Re: Savage Property
2730 Jennings Chapel Rd., Woodbine, MD
Variance Request
Setback to the wells on Lot 3 and Parcel 2 from Sewage Disposal Area on Lot 1

Re: Savage Property
2730 Jennings Chapel Rd. Woodbine, MD
Perc Testing Plan Response Letter

RE: Savage Property perc proposal

Re: Savage Property
2730 Jennings Chapel Rd. Woodbine, MD
Perc Testing Plan Response Letter

Basement parcel 1. Two septic stacks along the rear wall and one in the corner near the oil tank.

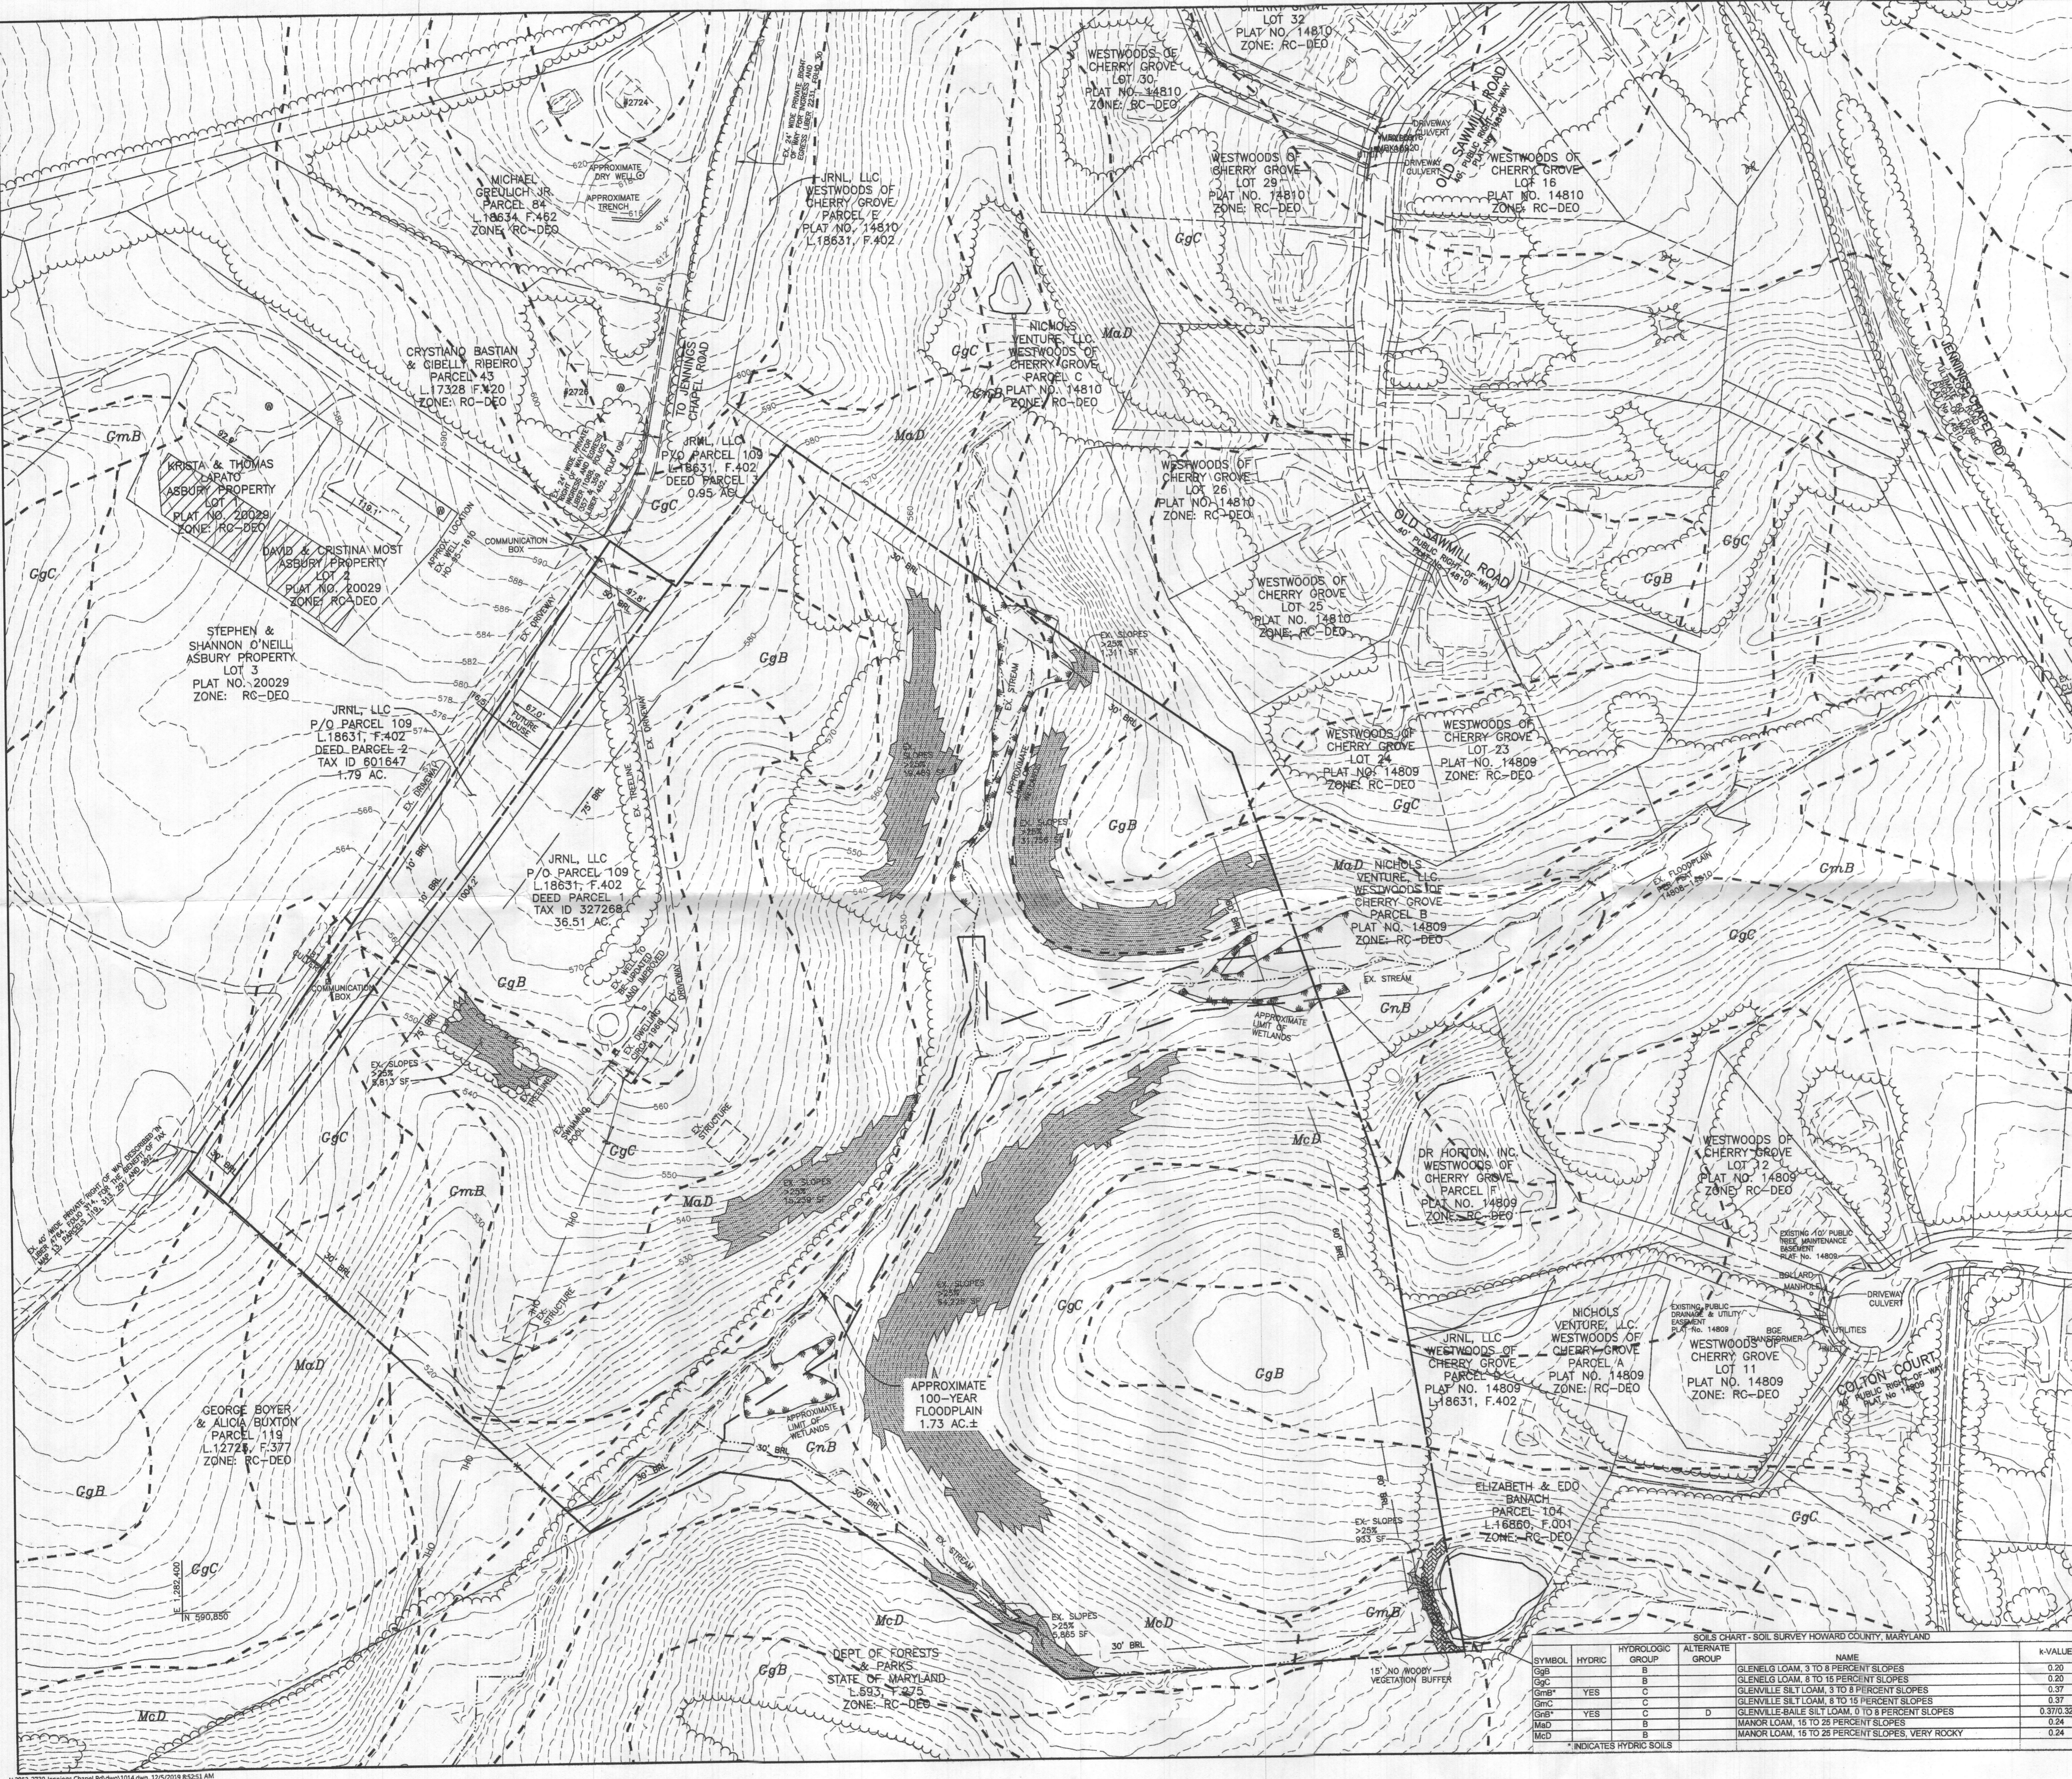
5) **The septic system components of the existing house on parcel 1 must be shown:**

Response: The surveyors investigated the location of the septic components for this lot. No components were visible outside the house. Here are pictures of the basement of this house. They show three locations where the septic stacks enter the basement slab. A note has been added to the plan to require the location and proper abandonment of the septic components for this house when replacement is necessary.

PERCOLATION CERTIFICATION PLAN

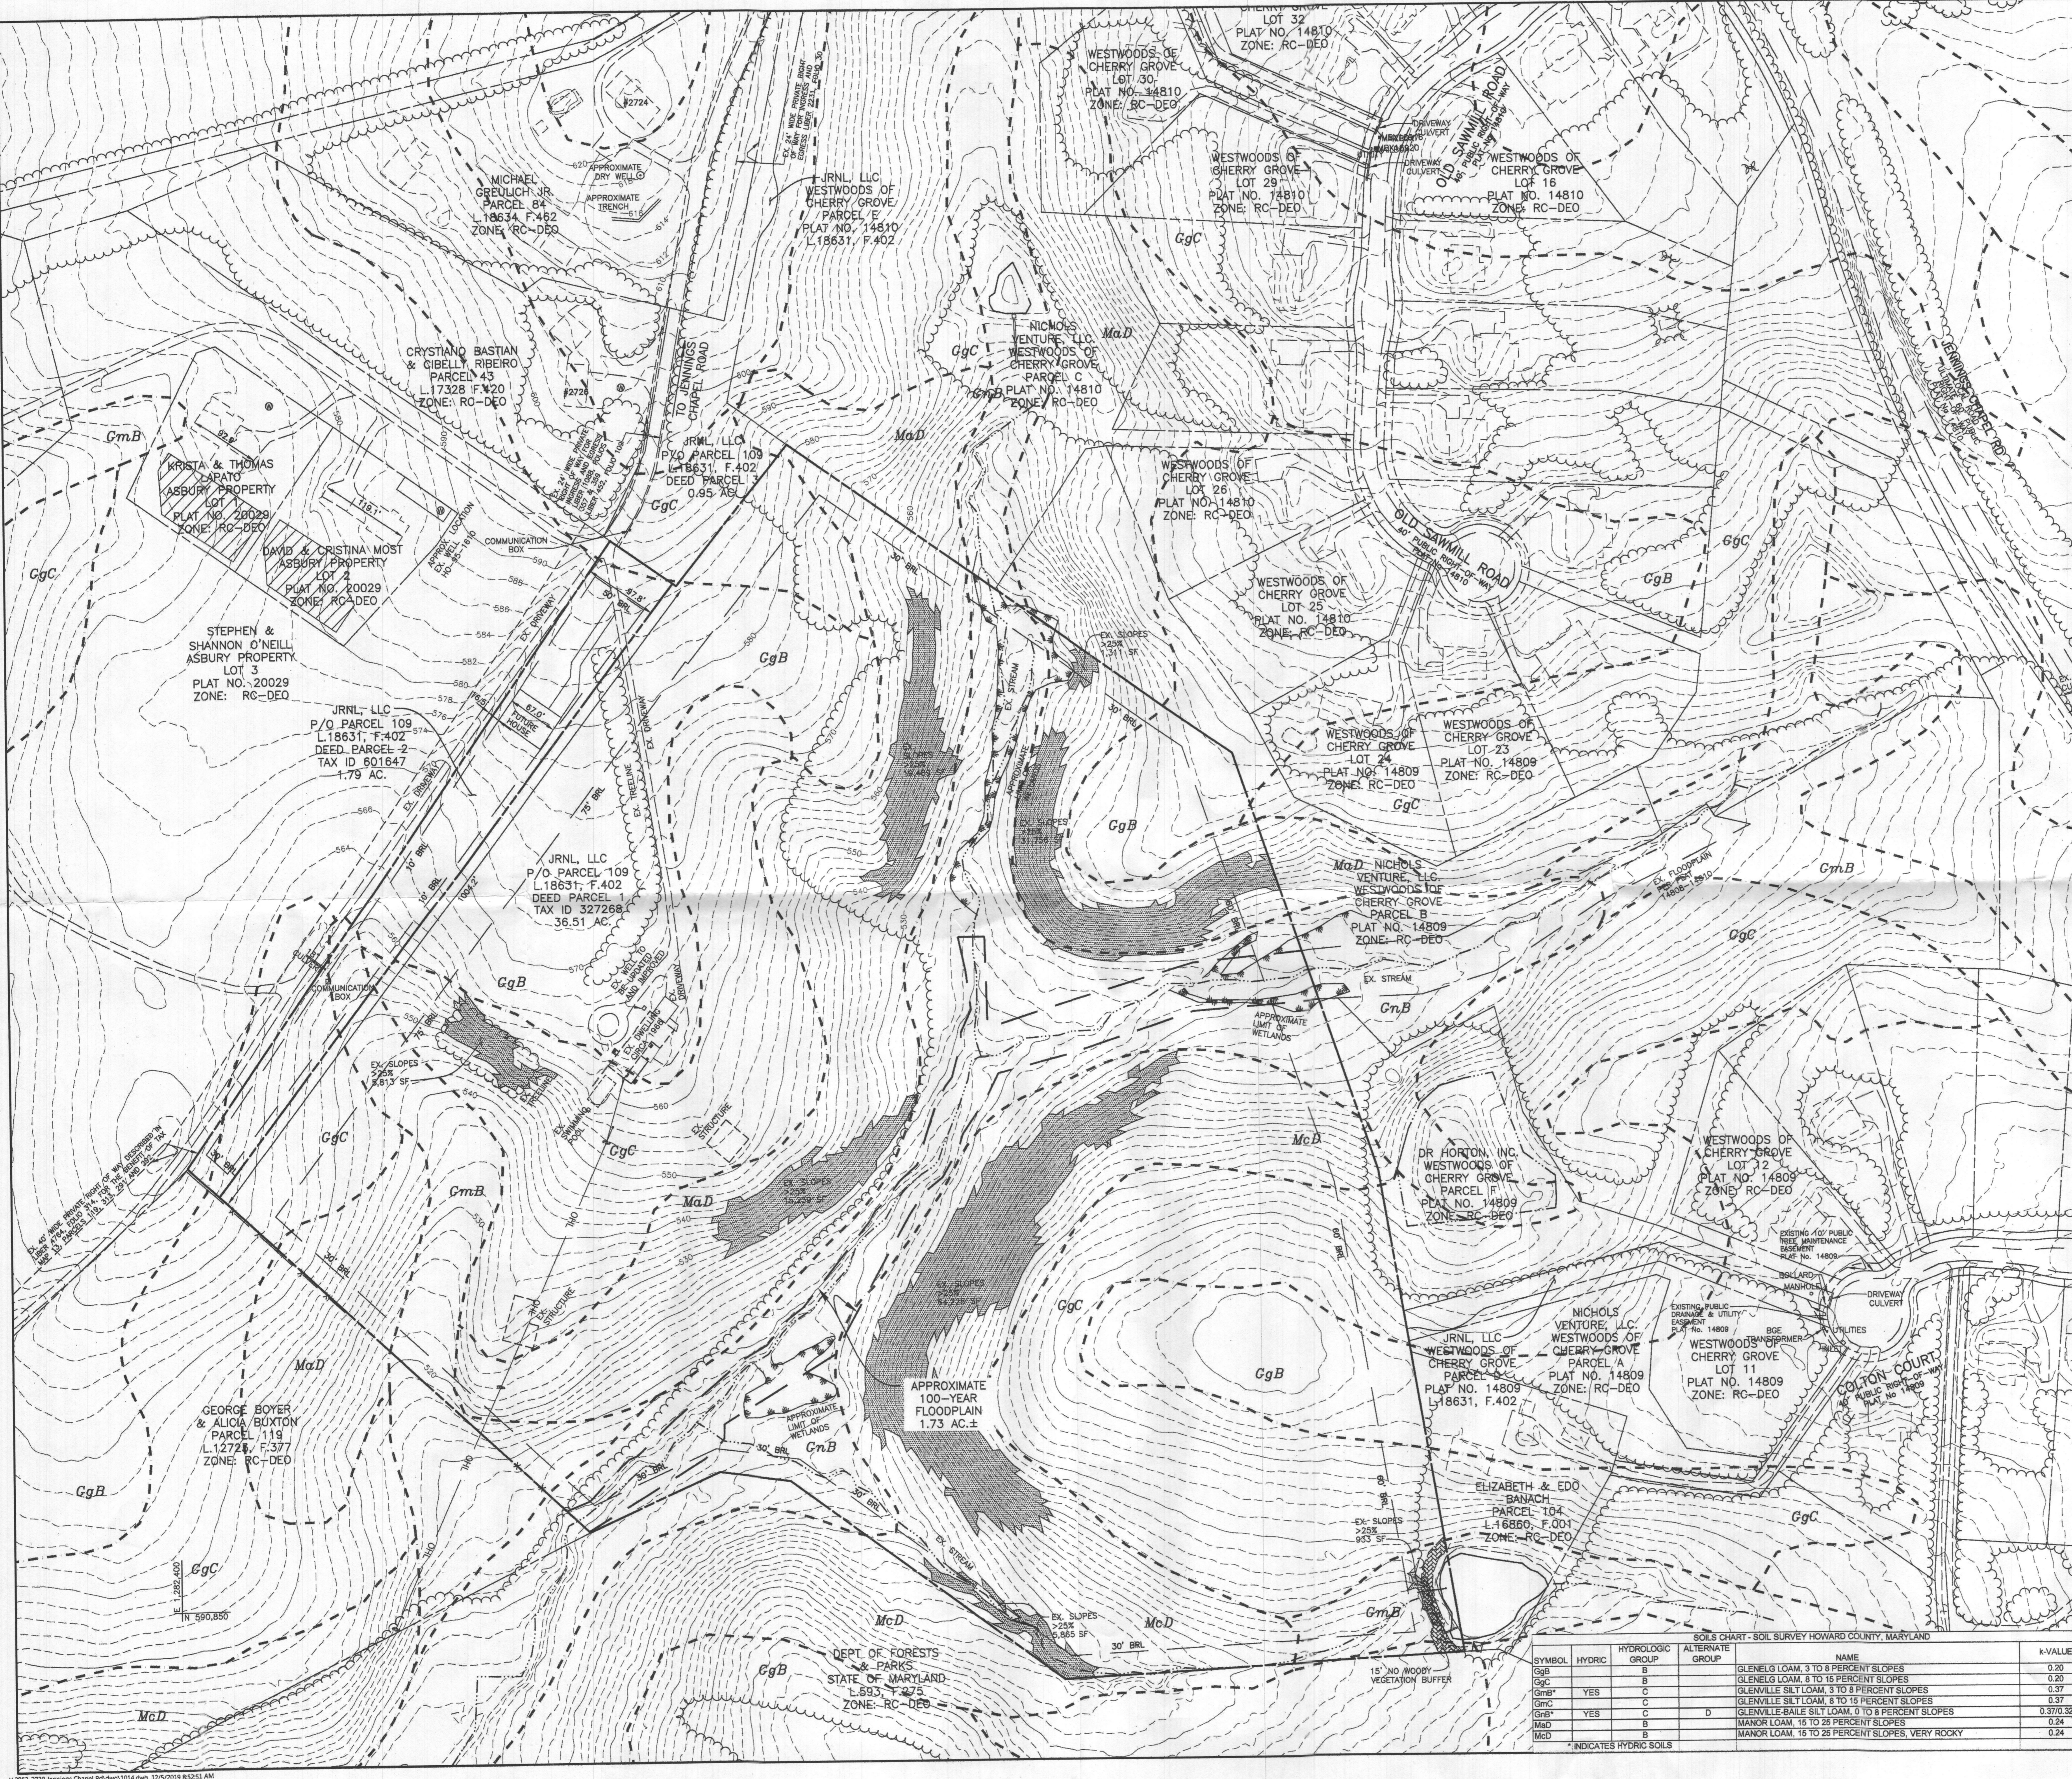
1) Well Zone lot 1 less than 1500 sf:

2) Lot 1 well zone less than 200 feet from upgradient septic system at 2724 Jennings Chapel Rd.:

3) Septic components of 2724 Jennings Chapel Road are not shown:

4) Well and septic components of 2726 Jennings Chapel Road are not shown:

6) **General note 6, replace "easement" with "area":**

7) **Delete note 7 regarding groundwater appropriations permit:**

8) **Edit note 12, according to the information provided here and above and the information found by Benchmark Engineering, Inc.:**

Response: Well zone has been reconfigured and the area has been verified to be above 1500 sf.

Response: The septic components of 2724 Jennings Chapel Road have been added to the plan and at least 200' of separation distance has been provided. The dry well clean out has been located and the trench shown off that and the house per the installation sketch.

Response: The septic components of 2724 Jennings Chapel Road have been added to the plan. The dry well clean out has been located and the trench shown off that and the house per the installation sketch.

are were not found. The approved percolation certification plans for Asbury lots 1 and 2 do not show the septic location for #2726 Jennings Chapel Road. The final plans for Asbury Property do not show this adjoining septic or well. Based on images available on Trulia.com the septic stack is at the rear of the house. It is assumed that the septic is behind the house and will not impact the well on lot 1.

Response: Note 6 has been revised as requested.

Response: Note 7 has been removed as requested.

Response: Note 12 has been revised per the information.

- FIELD INVESTIGATION INTO THE LOCATION OF THE EXISTING SEPTIC COMPONENTS FOR THE EXISTING HOUSE ON PARCEL 1 DID NOT REVEAL ANY COMPONENTS EXCEPT THE SEPTIC LINES INTERNAL TO THE HOUSE. THE EXTERIOR SEPTIC COMPONENTS MUST BE LOCATED AND PROPERLY ABANDONED AT THE TIME A NEW SEPTIC IS NECESSARY.
